SERVICE BULLETIN REVISION TRANSMITTAL SHEET

TITLE: AIR CONDITIONING - AIR DISTRIBUTION AND RECIRCULATION - CHANGE CONTACT SIZE

FOR SUPPLY CABLE OF FANS 14HG, 15HG AND 1HU.

This page transmits Revision No. 01 of Service Bulletin No. A320-21-1172.

Figure 7, Sheet 1
Config. 01 thru 02: Modification of the Wiring of the LH Recirculation Fan FIN 15HG in the Rear Panel 120VU

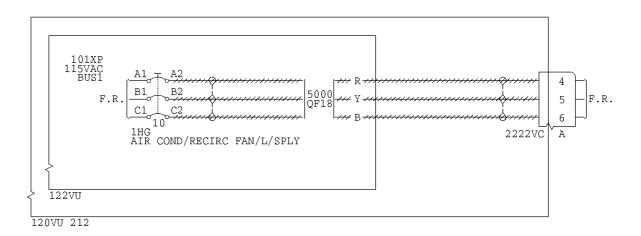
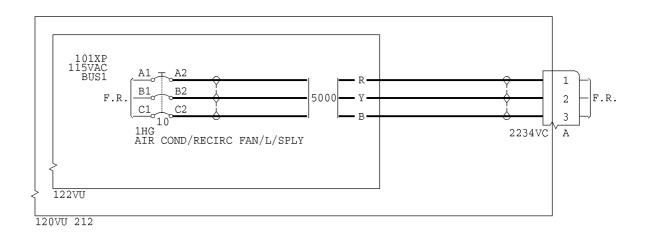
(c) Modify the wiring of the LH recirculation fan FIN 15HG in the rear panel 120VU. Refer to Kit 211172A01R00 Refer to Figure 7, Sheet 1

- Remove the wires as shown on the wiring diagram, Figure 7, Sheet 1 and as given in the Hook-up Chart lines:
 - 1 thru 3 (Refer to Figure 8 Sheet 1).
- Install the wires as shown on the wiring diagram, Figure 7, Sheet 1 and as given in the Hook-up Chart lines:
 - 7 thru 9 (Refer to Figure 8 Sheet 1) supplied in :

Figure 9, Sheet 1
Config. 03 thru 04: Modification of the Wiring of the LH Recirculation Fan FIN 15HG in the Rear Panel 120VU

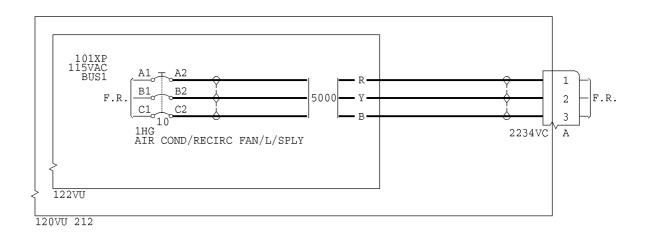
Refer to Figure 9, Sheet 1

- 1 Remove the wires as shown on the wiring diagram, Figure 9, Sheet 1 and as given in the Hook-up Chart lines :
 - 1 thru 3 (Refer to Figure 10 Sheet 1).
- 2 Install the wires as shown on the wiring diagram, Figure 9, Sheet 1 and as given in the Hook-up Chart lines :
 - 7 thru 9 (Refer to Figure 10 Sheet 1) supplied in :

Figure 13, Sheet 1
Config. 03 thru 04: Modification of the Wiring of the RH Recirculation Fan FIN 14HG in the Rear Panel 120VU

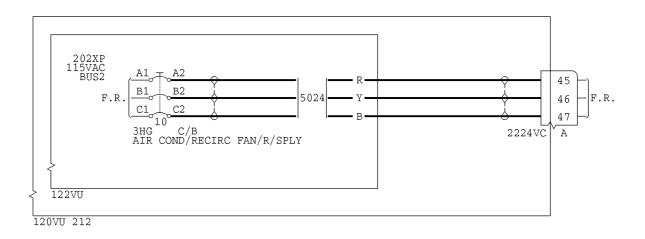
Refer to Kit 211172A01R00 Refer to Figure 13, Sheet 1 Refer to Figure 14, Sheet 1

- 1 Remove the wires as shown on the wiring diagram, Figure 13, Sheet 1 and as given in the Hook-up Chart lines:
 - 1 thru 3 (Refer to Figure 14 Sheet 1).
- 2 Install the wires as shown on the wiring diagram, Figure 13, Sheet 1 and as given in the Hook-up Chart lines:
 - 7 thru 9 (Refer to Figure 14 Sheet 1) supplied in :

Figure 27, Sheet 1

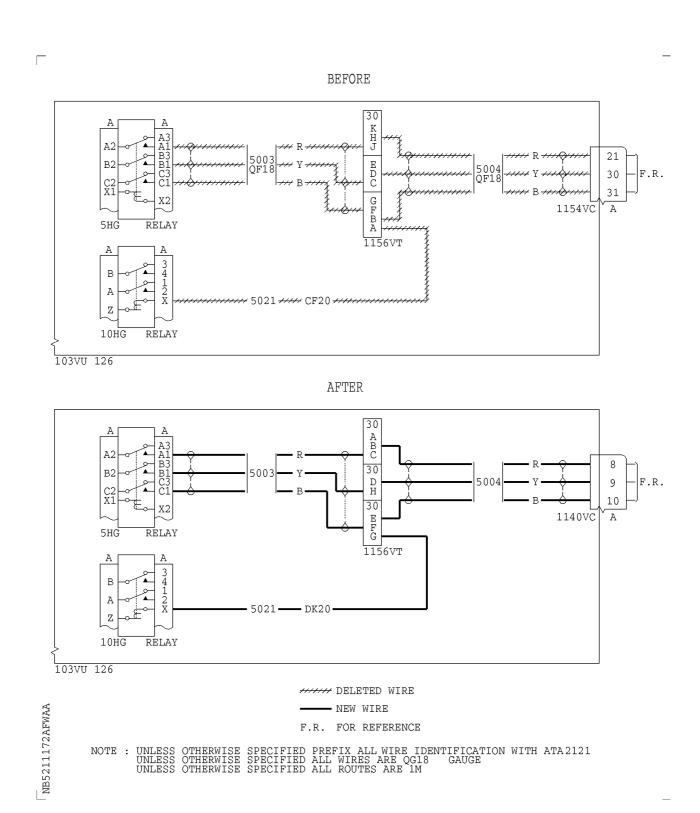
- Remove the wires as shown on the wiring diagram, Figure 25, Sheet 1 and Figure 27, Sheet 1 and as given in the Hook-up Chart lines:
 - 1 thru 3 (Refer to Figure 26 Sheet 1).
 - 1 thru 7 (Refer to Figure 28 Sheet 1).
- Install the wires as shown on the wiring diagram, Figure 25, Sheet 1 and Figure 27, Sheet 1 and as given in the Hook-up Chart lines :
 - 7 thru 9 (Refer to Figure 26 Sheet 1) supplied in :

Figure 37, Sheet 1

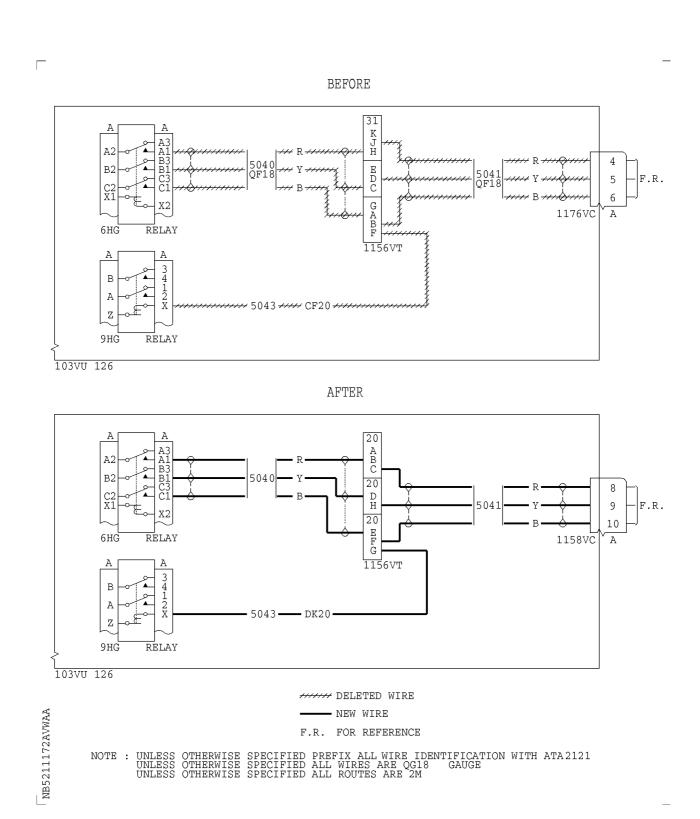
Bundle D9000095222795 Attach the wires with: 30 Tie-Cable NSA935401-03 30 Tie-Cable NSA935401-05 30 Tie-Cable NSA935401-08 (I) Modify the wiring of the RH recirculation fan FIN 14HG in the relay box 103VU. Refer to Kit 211172A01R00 Refer to Figure 3, Sheet 1 Refer to Figure 35, Sheet 1 Refer to Figure 36, Sheet 1 Refer to Figure 37, Sheet 1 Refer to Figure 38, Sheet 1 On the terminal 1156VT, remove in position 31: Refer to Figure 3, Sheet 1 1 Module Item (15) Discard On the terminal 1156VT, remove in position 20: Refer to Figure 3, Sheet 1 1 Module-False NSA937901FM Item (16) Retain On the terminal 1156VT, install in position 31: Refer to Figure 3, Sheet 1 Module-False NSA937901FM Item (16) NOTE: The False-Module Item (16) was retained at the removal. On the terminal 1156VT, install in position 20: Refer to Figure 3, Sheet 1 1 Module NSA937901M16-06 Item 15 Label Identification NSA937901E2 1 Label Identification NSA937901E0 Remove the wires as shown on the wiring diagram, Figure 35, Sheet 1 and Figure 37, Sheet 1 and as given in the Hook-up Chart lines: - 1 thru 3 (Refer to Figure 36 Sheet 1).

Install the wires as shown on the wiring diagram, Figure 35, Sheet 1 and Figure

Figure 45, Sheet 1

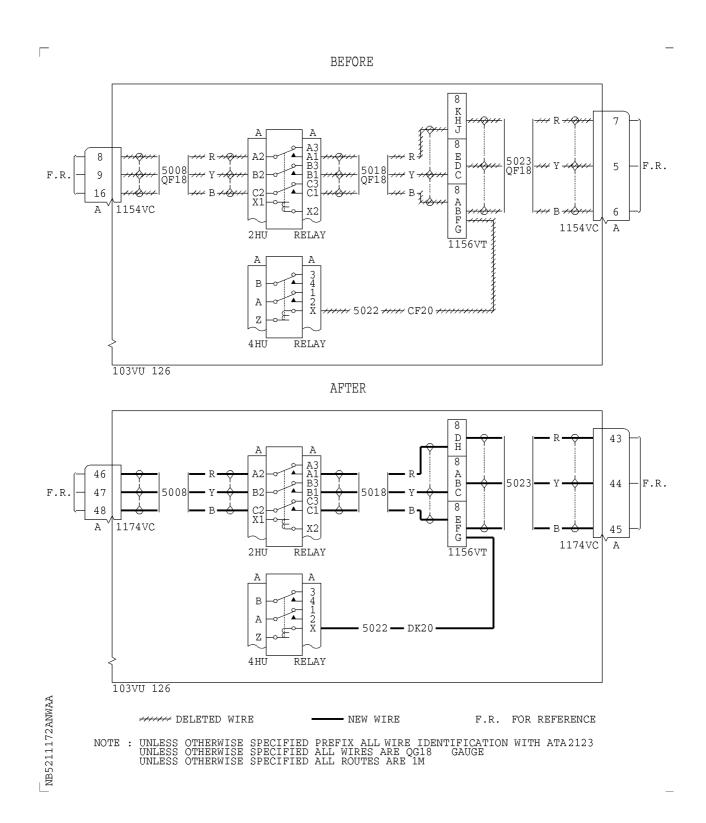
- 3 Remove the wires as shown on the wiring diagram, Figure 45, Sheet 1 and as given in the Hook-up Chart lines:
 - 1 thru 10 (Refer to Figure 46 Sheet 1).
- 4 Install the wires as shown on the wiring diagram, Figure 45, Sheet 1 and as given in the Hook-up Chart lines :
 - 14 thru 23 (Refer to Figure 46 Sheet 1) supplied in :

Figure 47, Sheet 1

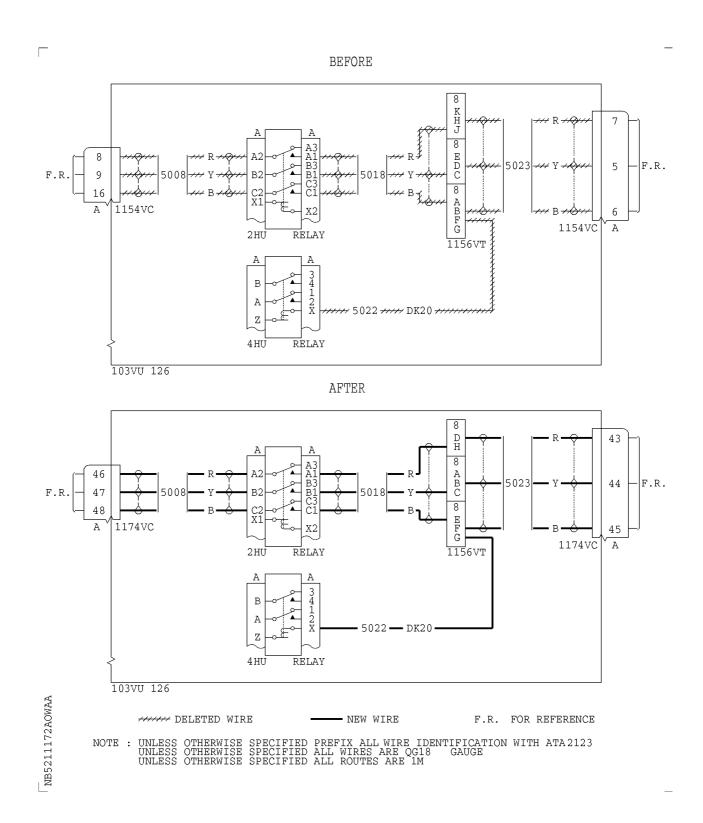
- 1 Remove the wires as shown on the wiring diagram, Figure 47, Sheet 1 and as given in the Hook-up Chart lines :
 - 1 thru 10 (Refer to Figure 48 Sheet 1).
- Install the wires as shown on the wiring diagram, Figure 47, Sheet 1 and as given in the Hook-up Chart lines :
 - 14 thru 23 (Refer to Figure 48 Sheet 1) supplied in :

Figure 59, Sheet 1 Config. 01 thru 03 : Rerouting of Electrical Wires and Installation of Plug 1953VC-A

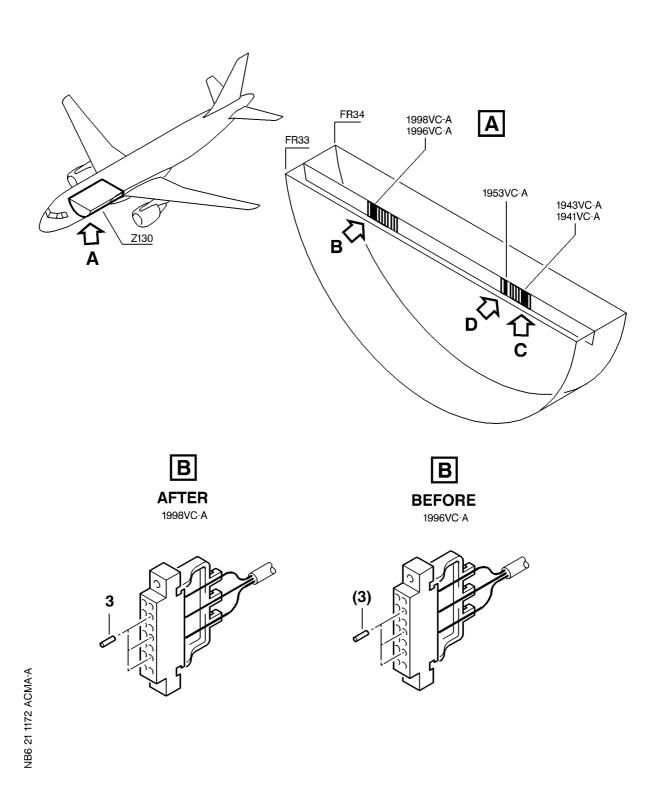
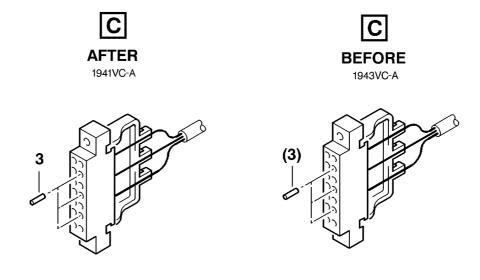
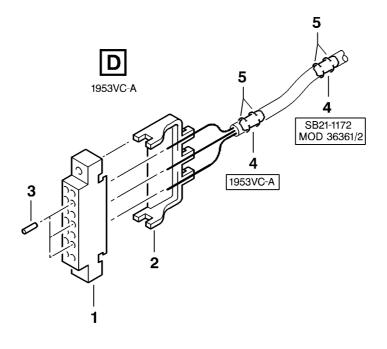
Refer to Figure 59, Sheet 1, Detail B, BEFORE

3 Pin Item (3) Discard Reroute the electrical wires from plug 1996VC-A to plug 1998VC-A: Refer to Kit 211172D01R00 Refer to Figure 59, Sheet 1, Detail B, AFTER Refer to Figure 61, Sheet 2 Refer to Figure 63, Sheet 1, END1, Lines 9, 11 and 13 EN3155-008M1614 3 Pin Modify the electrical wiring for the recirculation fan, FIN 15HG. Refer to Kit 211172D01R00 Refer to Figure 59 Refer to Figure 61, Wiring Diagram Refer to Figure 63, Hookup Chart 1 Remove the electrical wires from plug 1943VC-A: Refer to Figure 59, Sheet 2, Detail C, BEFORE Refer to Figure 61, Sheet 1 Refer to Figure 63, Sheet 1, END1, Lines 1, 3 and 5 3 Pin Item (3) Discard Reroute the electrical wires from plug 1943VC-A to plug 1941VC-A: Refer to Kit 211172D01R00 Refer to Figure 59, Sheet 2, Detail C, AFTER Refer to Figure 61, Sheet 2 Refer to Figure 63, Sheet 1,END1, Lines 2, 4 and 6 EN3155-008M1614 Item 3 Modify the electrical wiring for the extraction fan, FIN 1HU. Refer to Kit 211172D01R00 Refer to Figure 59 Refer to Figure 62, Wiring Diagram Refer to Figure 64, Hookup Chart 1 Remove the electrical wires from plug 1943VC-A: Refer to Figure 59, Sheet 2, Detail C, BEFORE Refer to Figure 62, Sheet 1, BEFORE

Figure 61, Sheet 1 Config. 01 thru 03 : Wiring Diagram

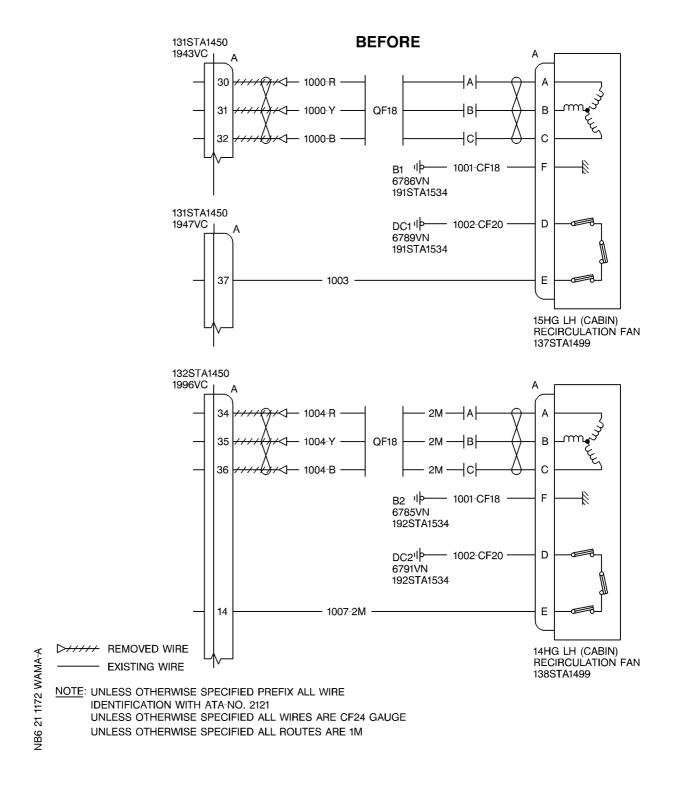
Refer to Figure 61, Sheet 1

Figure 61, Sheet 2 Config. 01 thru 03 : Wiring Diagram

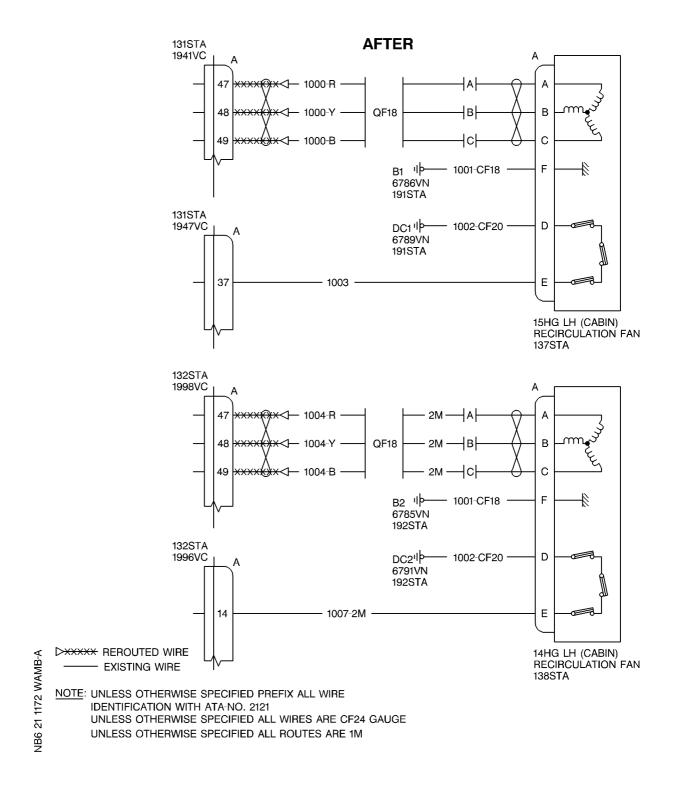
Refer to Figure 61, Sheet 2

Refer to Figure 61, Sheet 2

Figure 62, Sheet 1 Config. 01 thru 04 : Wiring Diagram

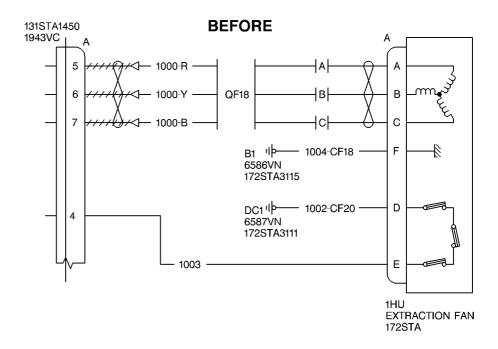
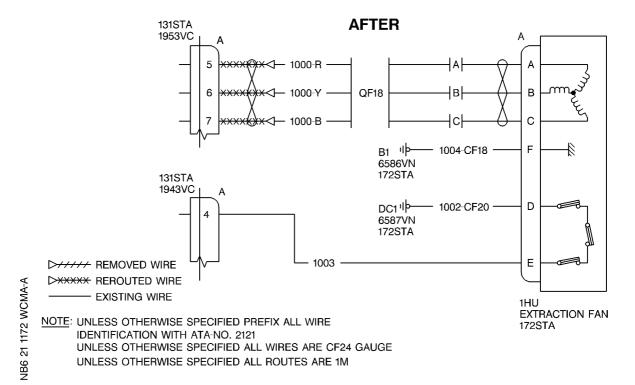
Refer to Figure 62, Sheet 1, BEFORE

3	Pin		Item (3)	Discard
		2 Rero	oute the electrical wire	es from plug 1943VC-A to th	e plug 1953V0	C-A :
		Refe	Refer to Kit 211172D01R00			
		Refe	Refer to Figure 59, Sheet 2, Detail D			
		Refe	Refer to Figure 62, Sheet 1, AFTER			
		Refe	Refer to Figure 64, Sheet 1, END1, Lines 2, 4 and 6			
		3 1 1	Pin Plug Backshell	EN3155-008M1614 EN3545E09MXA11A EN3545-007SCD	Item 3 Item 1 Item 2	
		3 Insta	all the plug 1953VC-A	:		
		Refer to Kit 211172D01R00				
		Refer to Figure 59, Sheet 1, Detail A				
		Refer to Figure 59, Sheet 2, Detail D				
		1 1	Plug Backshell	EN3545E09MXA11A EN3545-007SCD	Item 1 Item 2	
		4 Atta	ch the wire with:			
		Refer to Kit 211172D01R00				
		Refer to Figure 59, Sheet 2, Detail D				
		1	Placard set Tie	D9239440100400 NSA935401-03	Item 4 Item 5
